Subject: RE: Fort Lauderdale Country Club, Maintenance Facility Site, 415 E Country Club Circle **Attachments:** Figure5_Soil_8Ft (Black 1 20 12).pdf; Figure2_Soil_2Ft (Black 1 20 12).pdf; Figure3_Soil_

Subject: Fort Lauderdale Country Club, Maintenance Facility Site, 415 E Country Club Circle

I just received the Remedial Action Plan Addendum II (Modification) for the Fort Lauderdale Country Club Maintenance Facility. In an effort to quickly resolve any issues and expedite review, I am reaching out to you to request the following pieces of additional information that I need to issue approval:

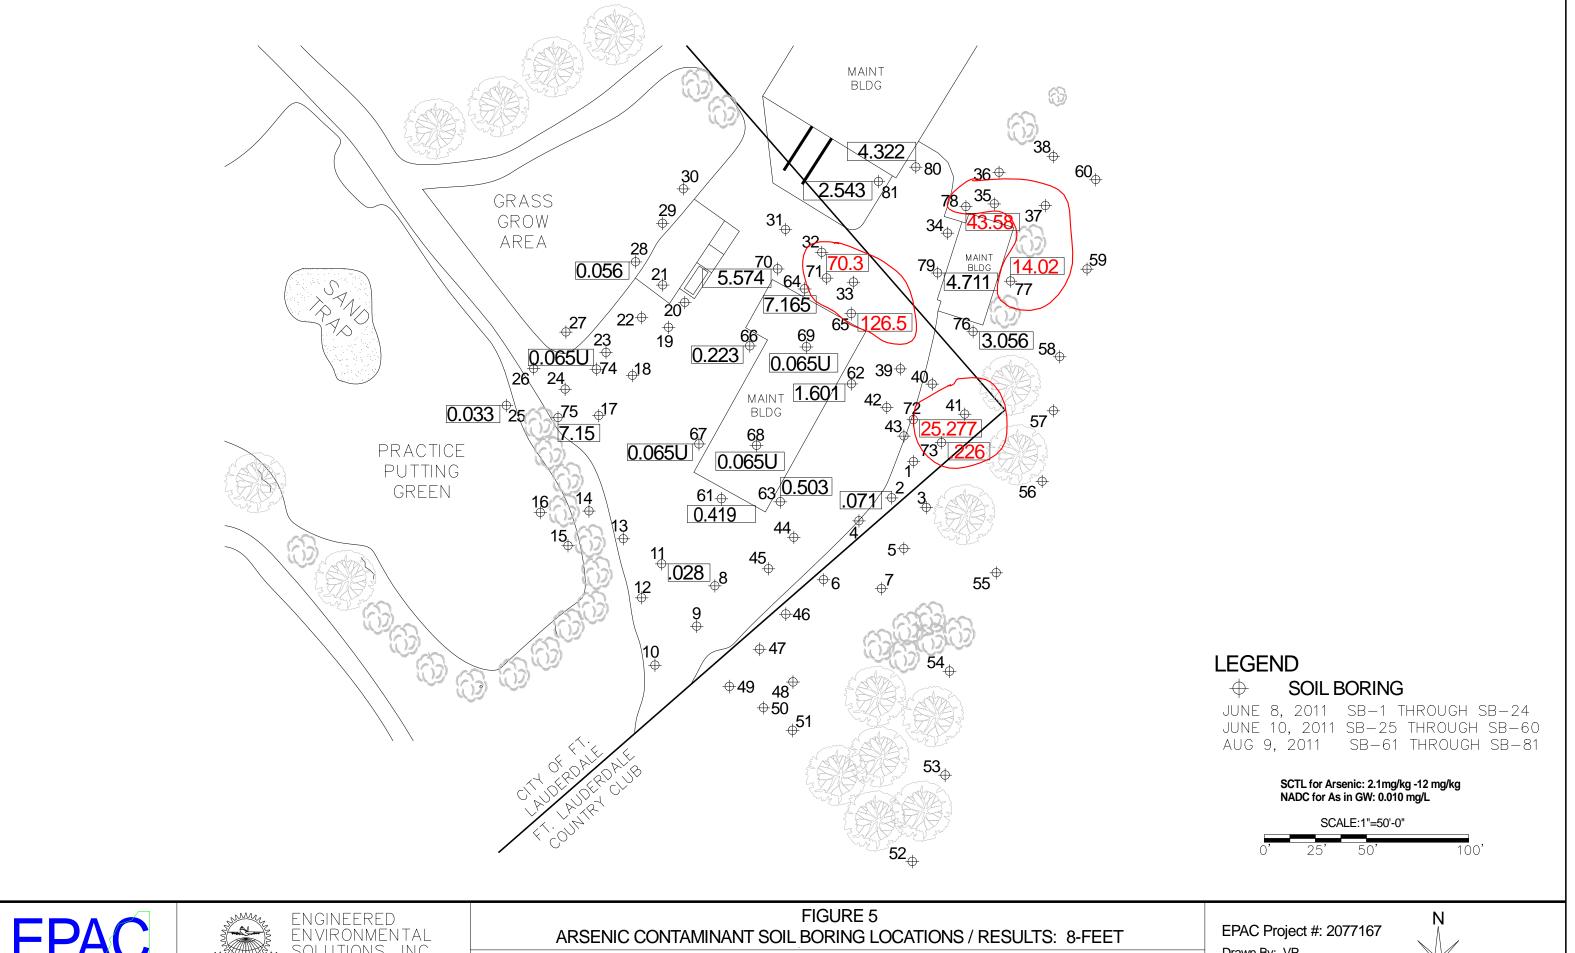
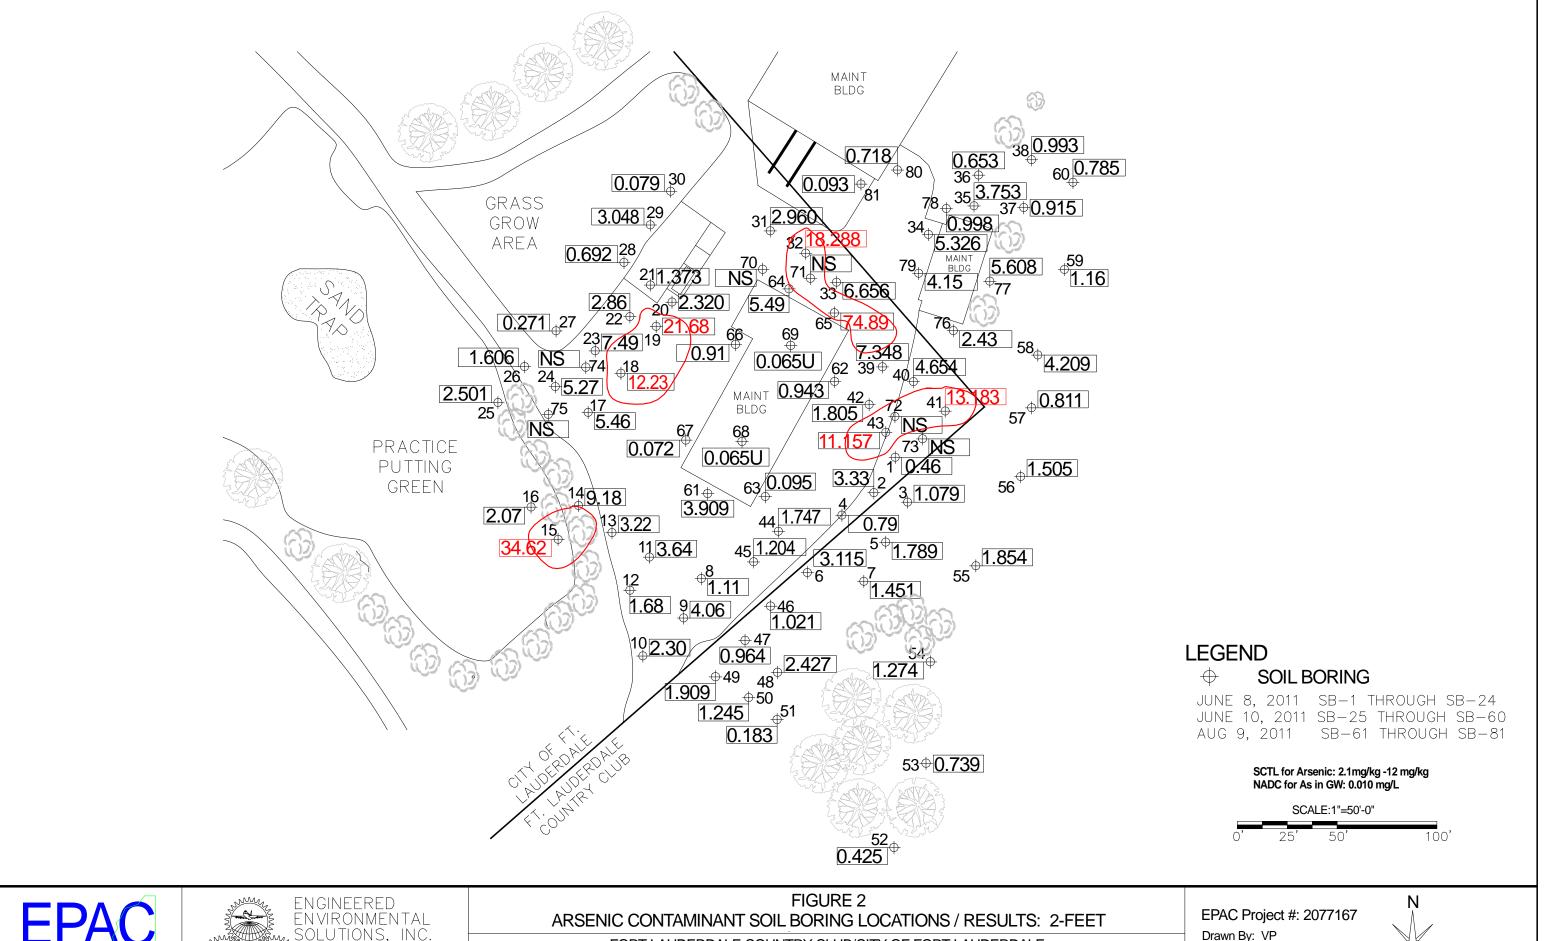
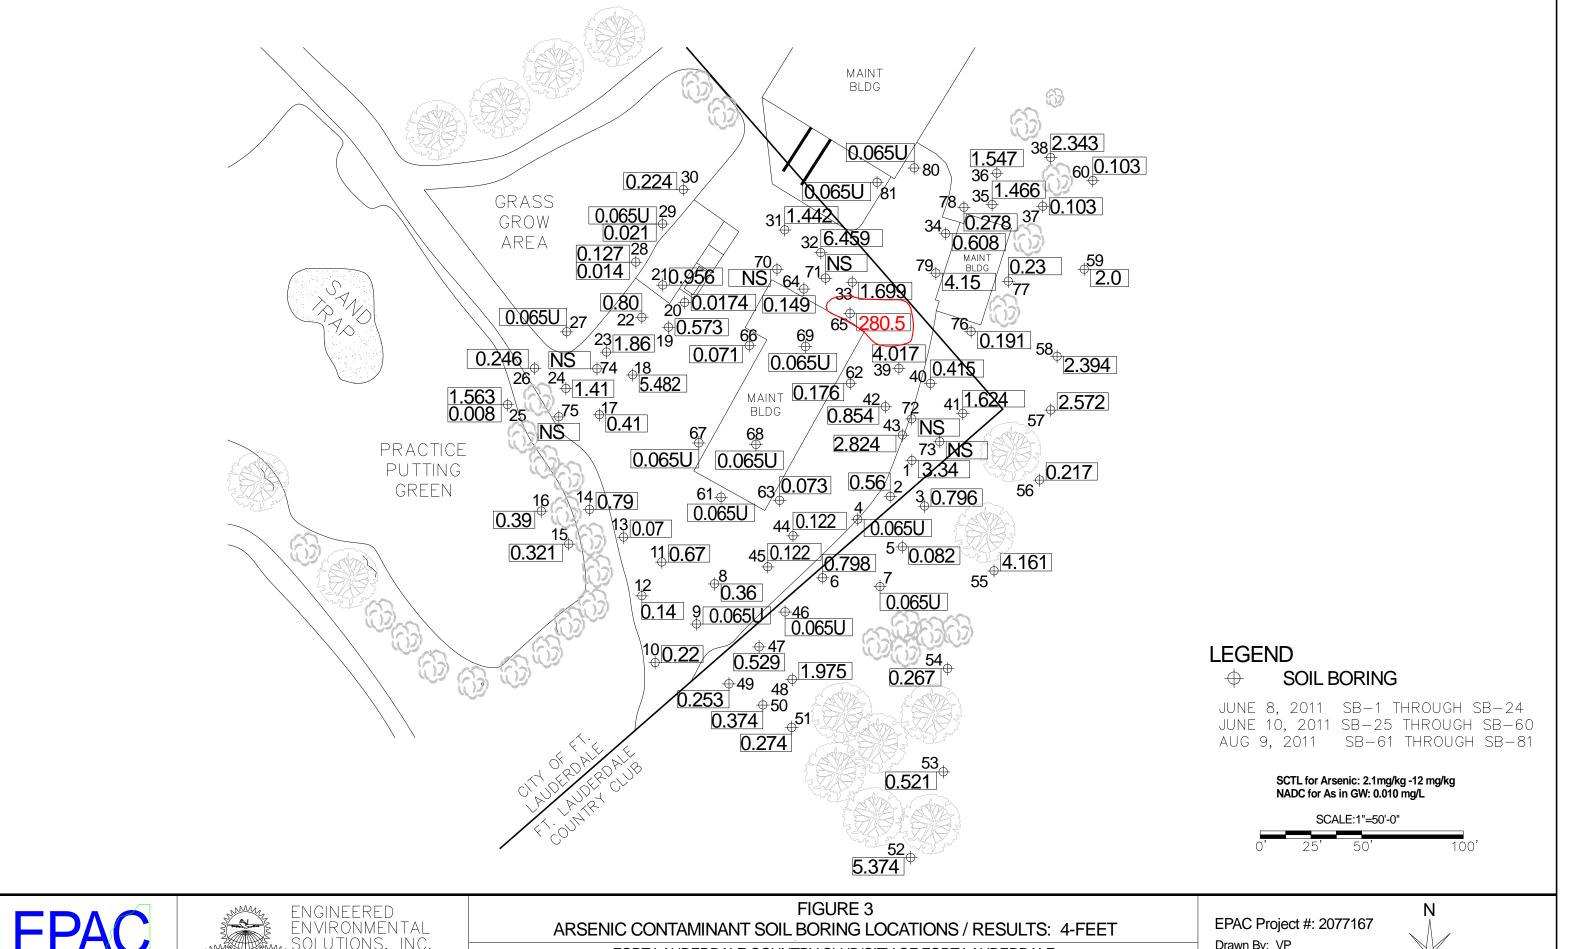
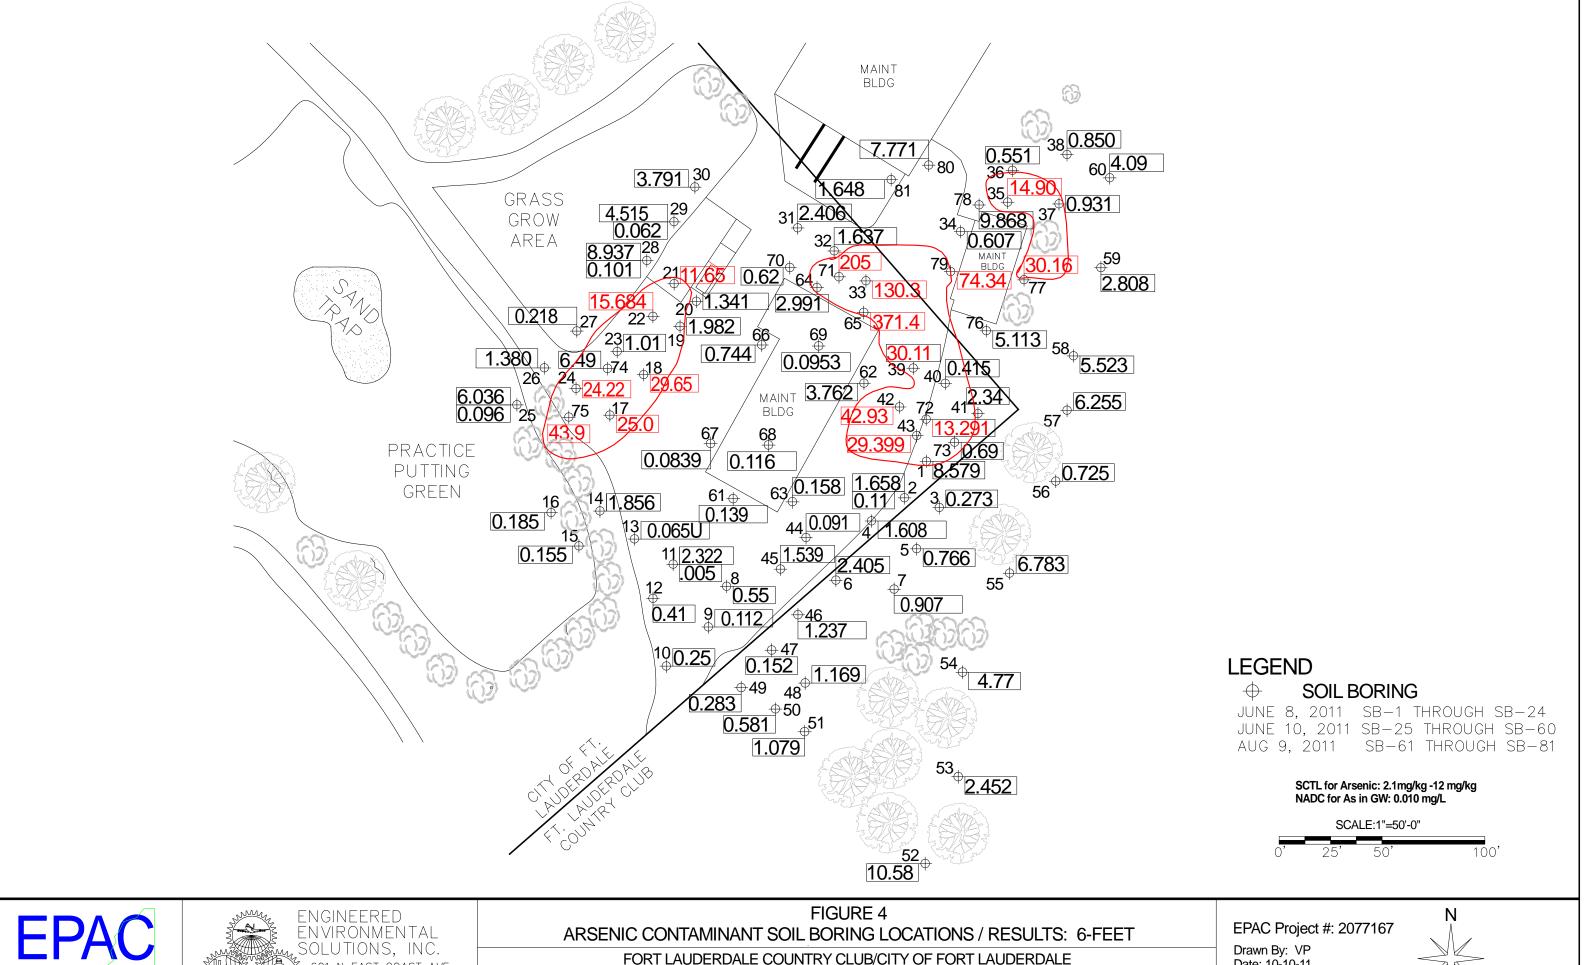
- 2) I need a figure that shows me the new estimated boundaries of excavation based upon assessment data, drawn to scale and showing site features. See Attached figures 2, 3, 4 and 5.

- I need a new estimate of the volume or tonnage of contaminated soils that are now to be removed from the site. Based on a revised 12 mg/kg standard, new maps of the contaminated soil areas indicates a total soil quantity of 1905 cubic yards of soil to be removed. Please understand that this figure will likely be higher as the exact extent of contamination will prove itself during the excavation process.
